UNITED STATES PATENT AND TRADEMARK OFFICE

APPLICATION NO.	FILING DATE	FIRST NAMED INVENTOR	ATTORNEY DOCKET NO.	CONFIRMATION NO.
10/748,308	12/29/2003	Seok-Jun Won	9898-304	7991

Office Action Summary

*FIG. 4*

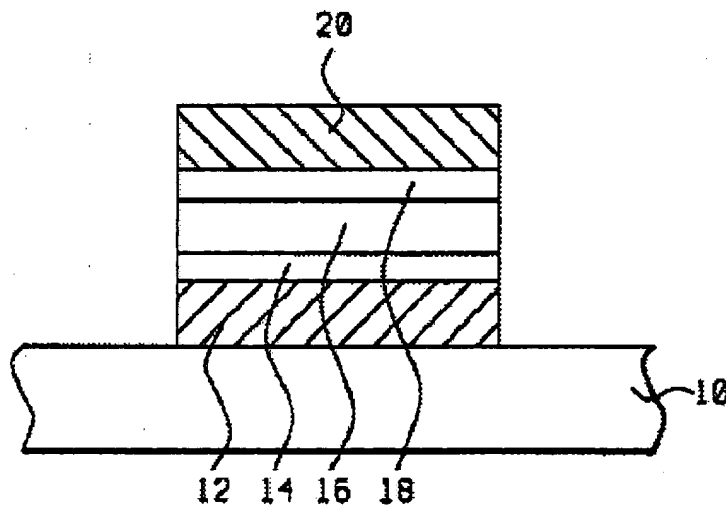
3. Claim 1-4 ,6-16, 20,22 are rejected under 35 U.S.C. 102(e) as being anticipated by Shih et al. (U.S. Patent Application Publication US 2003/0096473).

Shih et al. (the title, the abstract, fig 4, paragraph [0022] , paragraph [0023] , paragraph [0024]) disclose a capacitor of a semiconductor device comprising: a capacitor lower electrode

(fig 4 layer 12) disposed a semiconductor substrate; a first dielectric layer (fig 4 layer 14) comprising aluminum oxide disposed on the capacitor lower electrode; a second dielectric layer (fig 4 layer 16) comprising a material having a higher dielectric constant than that of aluminum oxide disposed on the first dielectric layer; a third dielectric layer (fig 4 layer 18) comprising aluminum oxide disposed on the second dielectric layer; and a capacitor upper electrode disposed (fig 4 layer 20) on the third dielectric layer and a method for manufacturing a capacitor of a semiconductor device, the method comprising: forming a capacitor lower electrode on a semiconductor substrate; forming a first dielectric layer comprising aluminum oxide on the capacitor lower electrode; forming a second dielectric layer comprising a material having a higher dielectric constant than aluminum oxide on the first dielectric layer; forming a third dielectric layer comprising aluminum oxide on the second dielectric layer; and forming a capacitor upper electrode on the third dielectric layer.

FIG. 5

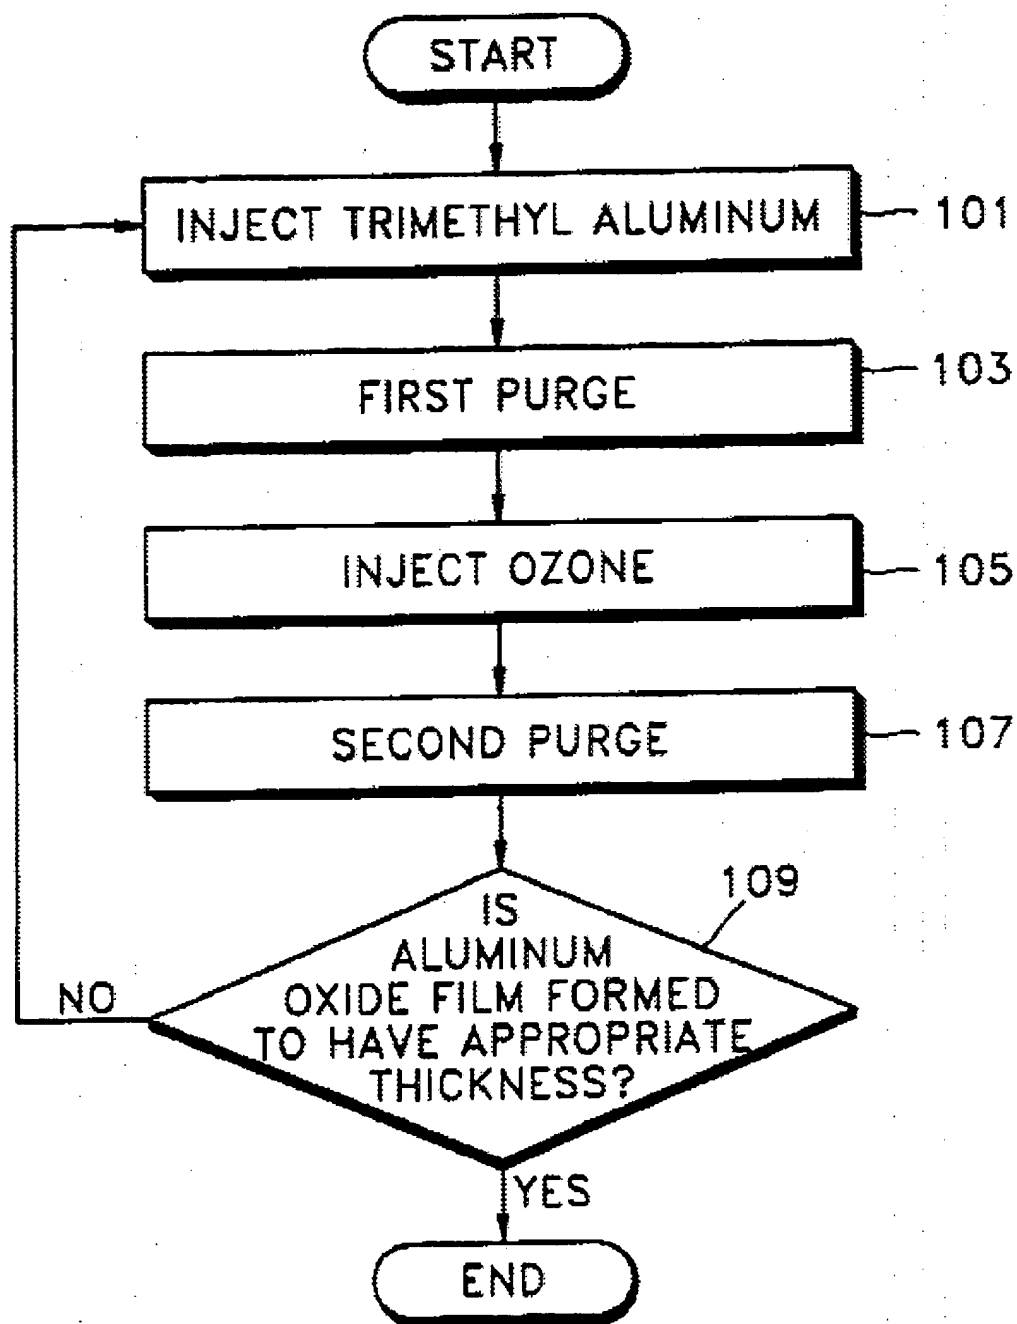
Shih discloses in paragraph [0022] the use of Atomic Layer Chemical Vapor Deposition Without going into detail about using the ALD to form the Aluminum Oxide using a gas include ozone or plasma oxygen without hydrogen.

This feature, however, has become known in the art as evidenced by the disclosure by Kim et al. (US patent 6,576,053) in the abstract and in fig 5.

A person skilled in the art at the time the invention was made would have been able to use this method from the teachings by Shih and his ordinary routine skill without any special teachings.
